Subject: POOR A/C PERFORMANCE	Bulletin No: 07-004/15
	Last Issued: 09/29/2015

2016 MX-5 vehicles with VINs lower than JM1ND*****103904 (produced before July 29, 2015)

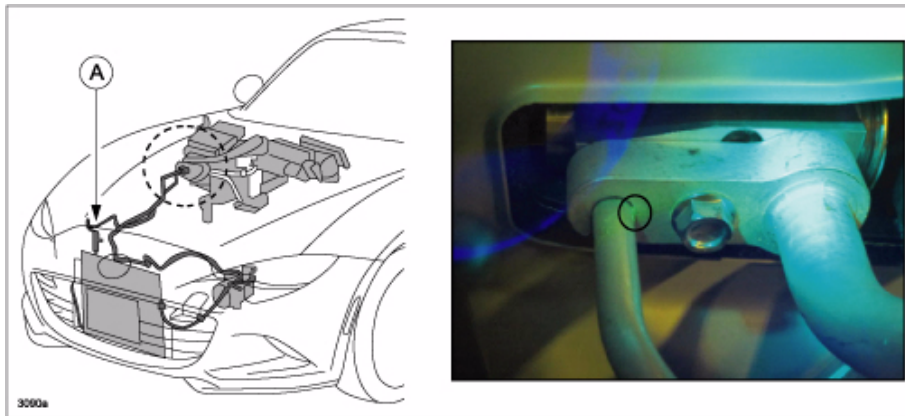
Some vehicles may experience poor A/C performance due to a slow refrigerant leak from the O-ring groove on the cooler pipe (high pressure side) at the expansion valve.

1. Verify customer concern.
2. Using a refrigerant leak detector or a black light, determine where the leakage is coming from.
 - If the leak is detected at the connection where the “Cooler Pipe (HI) C” connects to the expansion valve, replace the “Cooler Pipe (HI) C” (A) with a new one according to the instructions on MS3 online or the Workshop Manual (section 07-11 REFRIGERANT LINE REMOVAL/INSTALLATION).

Part Number	Description	Qty.	Notes
NA9C-61-465	Pipe No.2, Cooler	1	Replace if necessary
S31P-61-J17	O-ring	1	For cooler hose (LO) at expansion valve
